Salton Sea Independent Review Panel Fatal Flaw Report

Evaluation of Water Importation Concepts for Long-Term Salton Sea Restoration

Salton Sea Management Program

July 2022

Figure 4. Projected Salton Sea water salinity over time for responses with sufficient information for SSAM modeling, assuming a water import start date of 2030. The critical salinity tolerance range needed to sustain fish and wildlife of the Salton Sea ecosystem is depicted in blue shaded area.

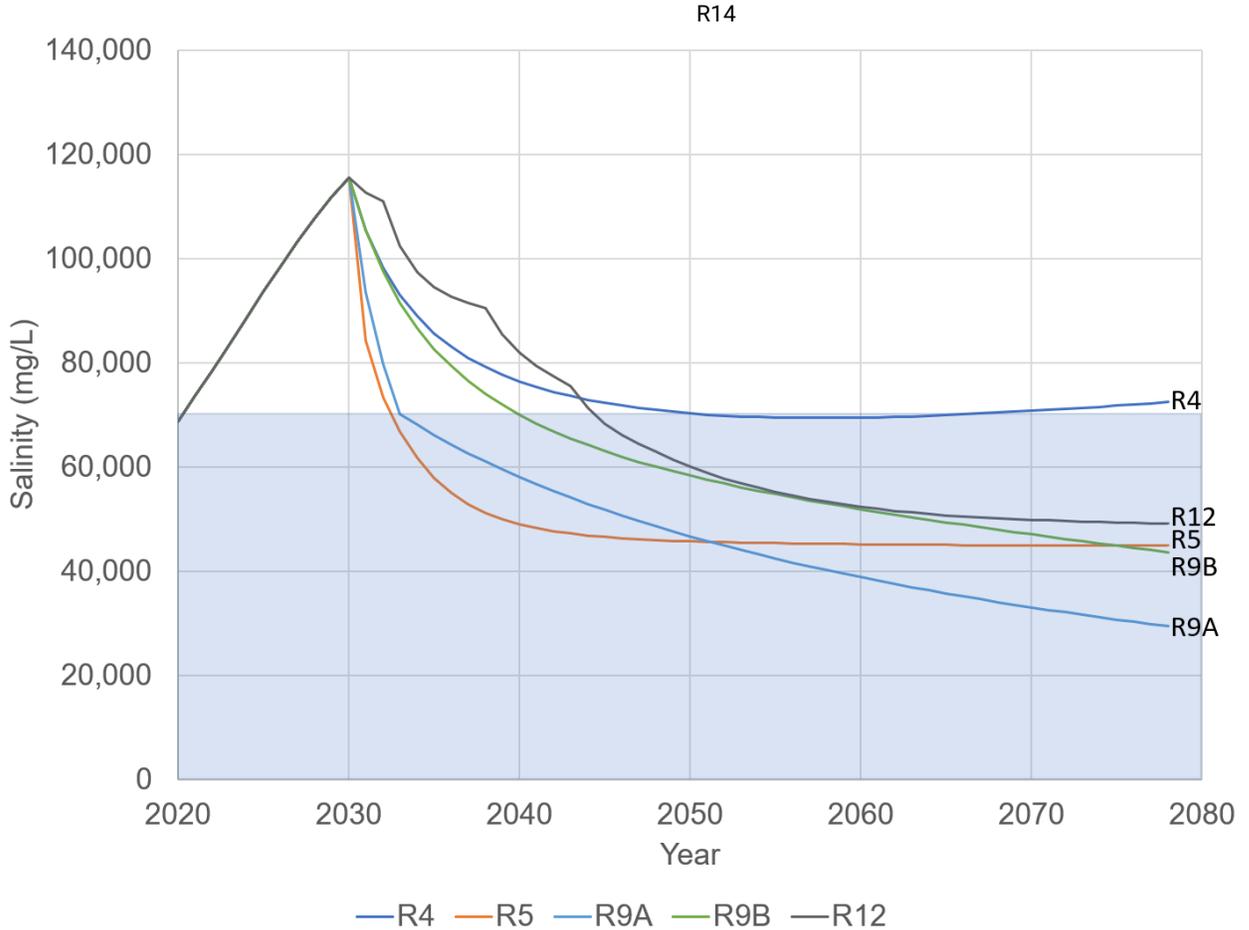
b. The response does not state a salinity goal, but Figure 4 shows salinity increasing above 70,000 mg/L with implementation of the project. Desalination of the imported water was proposed with a 25 MGD plant, expandable to 100 MGD; however, the timeline for implementation was not provided in the response. Assuming 100 MGD of desalination on the imported water, the salinity at the Salton Sea increases above the 70,000 mg/L goal. The

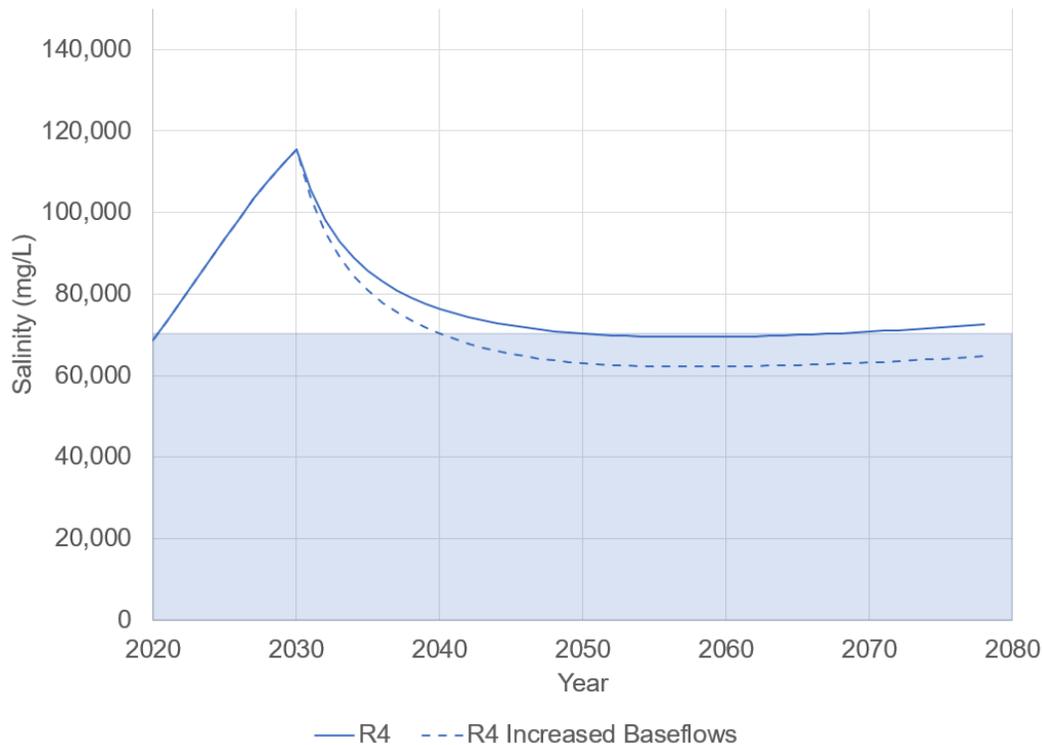
When accounting for uncertainty in the baseflows to the Salton Sea, one response (R4) may reach the target salinity range. Figure 5 illustrates the reduced salinity with increased baseflows.
